PLANT NAME: **Oconee 1-2-3**

ENCLOSURES:  
**ACKNOWLEDGED**  
**Response to Request for Additional Info Forwarded By R.A. Purple's ltr of 9-8-75 concerning Topical Report BAW-10103 .....**

Re: Oconee Nuclear Station  
Docket Nos. 50-269, -270, -287

RESPONSE TO REQUEST FOR ADDITIONAL INFORMATION  
FORWARDED BY MR. R. A. PURPLE'S LETTER OF  
SEPTEMBER 8, 1975

FIGURE 1  
FAN COOLER HEAT REMOVAL RATES

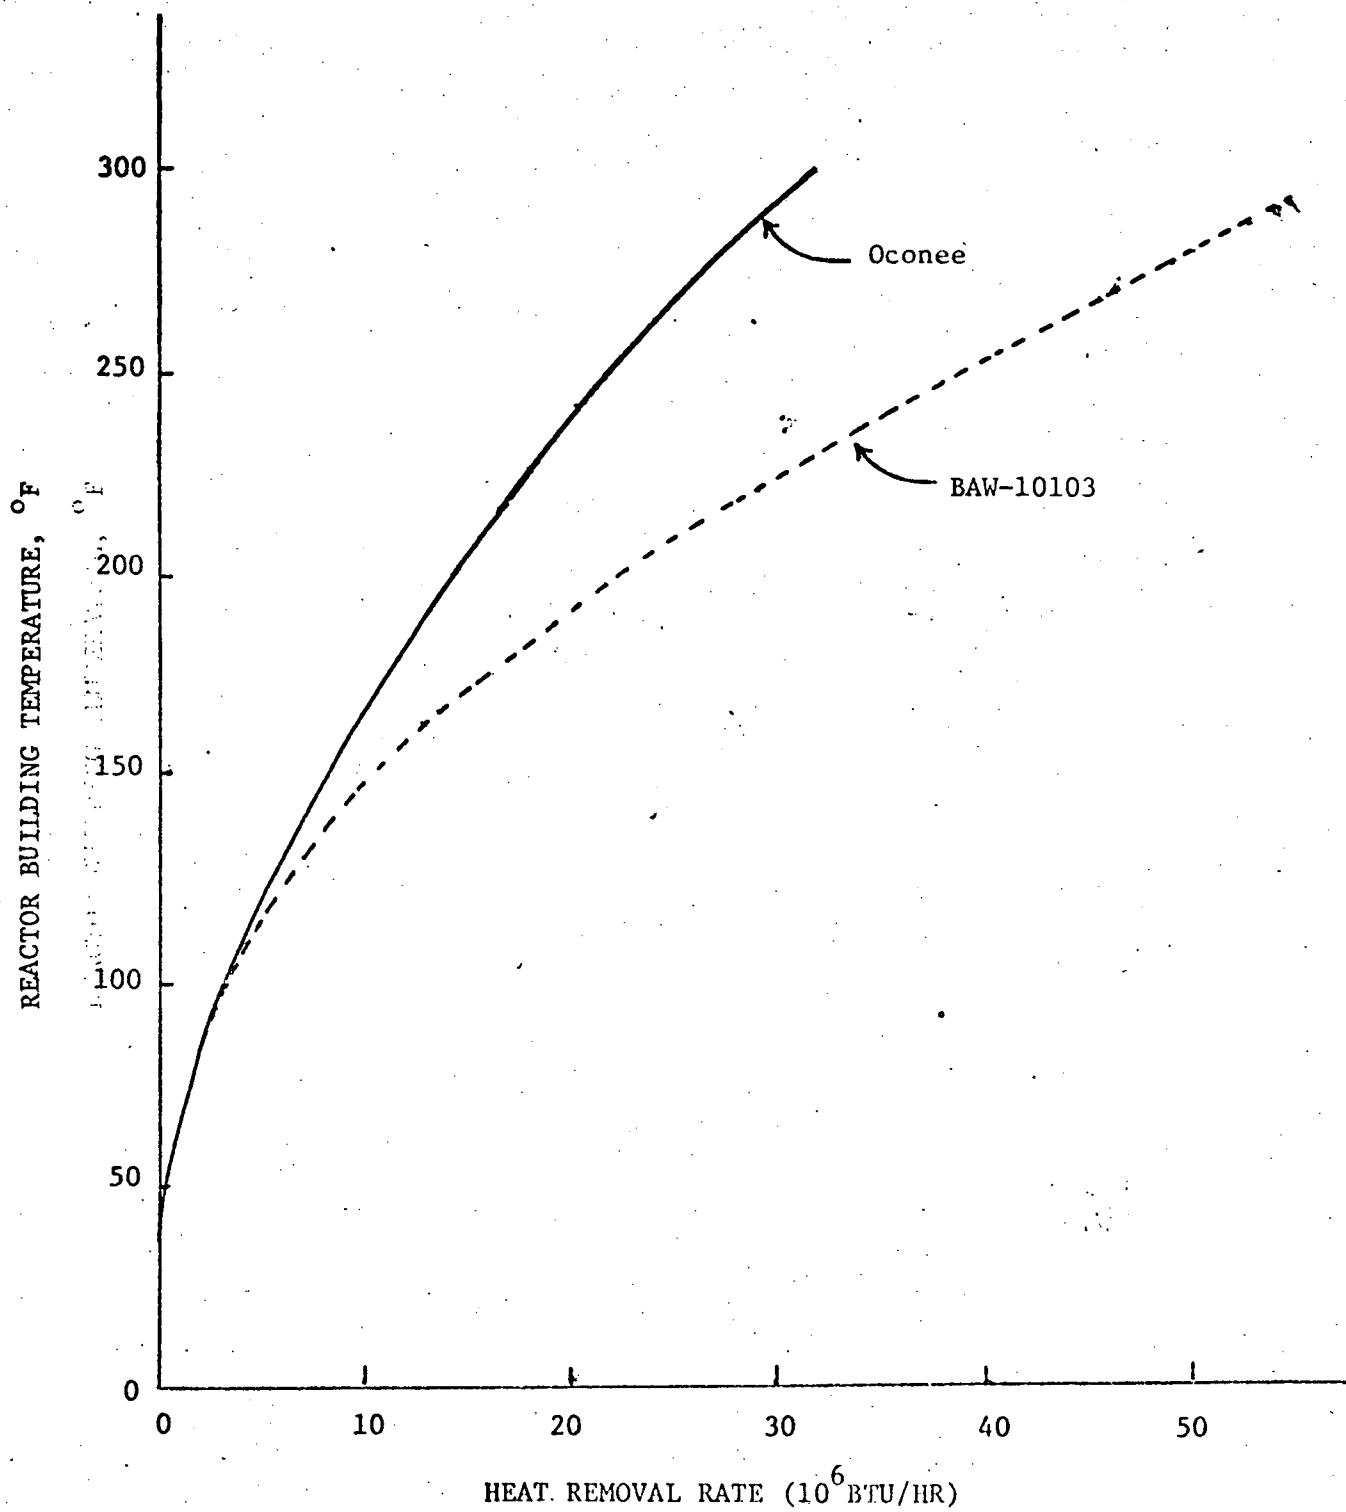
Fan-Cooler Heat Removal Rate - Compare the maximum fan-cooler heat removal rate for your plant with that assumed in BAW-10103. Show that minimum operational values of service water temperature have been used.

The maximum fan-cooler heat removal rate obtained from data presented in the FSAR and modified for 40F cooling water temperature is compared to that used in BAW-10103, in Figure 1. As can be seen from this comparison, the fan cooler heat removal rate assumed in BAW-10103 is equal to or greater than

that for Oconee at any given containment (RB) atmosphere temperature. The service water temperature used in both cases is 40F, however, the minimum operational value stated in the FSAR is 45F thereby adding additional conservatism.
